Access Compliance Report

Public Rights-of-Way

(Curb Ramps)

Intersection ID: 29247	Main Street: CASTELLO_LN	Cross Street: MALLARD_FOREST_DR	Location: SE
ADA ID: 46CC9FF5DA25	Ramp Type: BlendTrans1	Initial Pass/Fail: Fail	Overall Compliance: No
Severity Score: 18.75			
Codes/Mitigation Info/Possible Solution		Field Measurements/Component Compliance

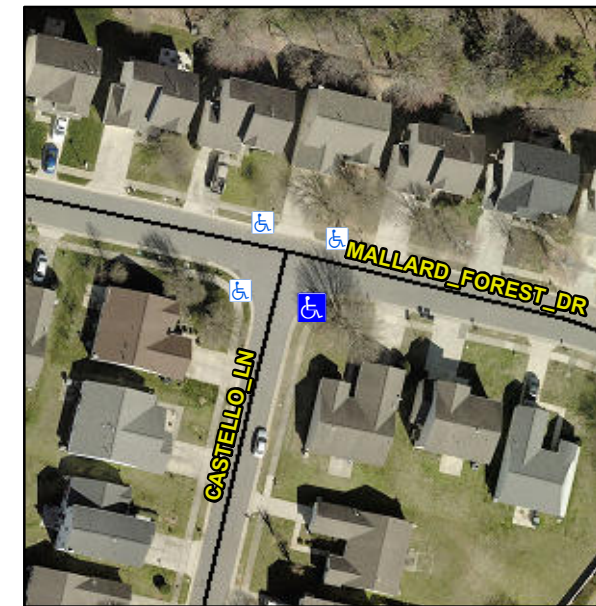
Not Found, R304.5.1, R304.5.3

Compliance	Description	Data	Compliance	Description	Data
N/A	Ramp Length (in)	48.0	Yes	BlendTrans Slope (%)	1.9
No	Ramp Width (in)	34.5	No	BlendTrans XSlope (%)	3.7
N/A	Flare Type LT	N/A	N/A	Flare Type RT	N/A
N/A	Flare Slope LT (%)	N/A	N/A	Flare Slope RT (%)	N/A
N/A	Flare Traversable LT?	N/A	N/A	Flare Traversable RT?	N/A
N/A	Landing Length (in)	N/A	N/A	DWS Provided?	N/A
N/A	Landing Width (in)	N/A	N/A	DWS Contrast?	N/A
N/A	Landing Slope (%)	N/A	N/A	DWS Length (in)	N/A
N/A	Landing X Slope (%)	N/A	N/A	DWS Full Width?	N/A
N/A	Landing Curb? (Y/N)	N/A	N/A	DWS Offset (in)	N/A
N/A	Shared Landing?	N/A			
N/A	Gutter Ponding?	N/A	N/A	Gutter Slope (%)	N/A
N/A	Gutter Lip Ht (in)	0.5	N/A	Gutter X Slope (%)	N/A
N/A	Painted X Walk1?	No	N/A	Painted X Walk2?	No
	X Walk 1 Direction	To N		X Walk 2 Direction	To W
	X Walk 1 Width (in)	N/A		X Walk 2 Width (in)	N/A
	X Walk 1 Slope (%)	4.3		X Walk 2 Slope (%)	4.7
	X Walk 1 X Slope (%)	0.0		X Walk 2 X Slope (%)	4.9

N/A	Ramp inside XWalk1?	N/A	N/A	Ramp inside XWalk2?	N/A
	Road Slope (%)	5.2		Clear Space?	N/A
	Road X Slope (%)	4.7	N/A	Clear Space to XWalk (in)	N/A
N/A	Any Obstructions?	N/A	N/A	Storm Grate/Utility Hazard?	N/A
	Obstruction Type			Storm Grate/Utility Type	
		N/A			N/A
			Yes	Surface Condition? (G/P)	Good
			No	Curb Slope (%)	14.3

Remove & Replace Curb Ramp With Two New Directional Ramps or Equivalent.
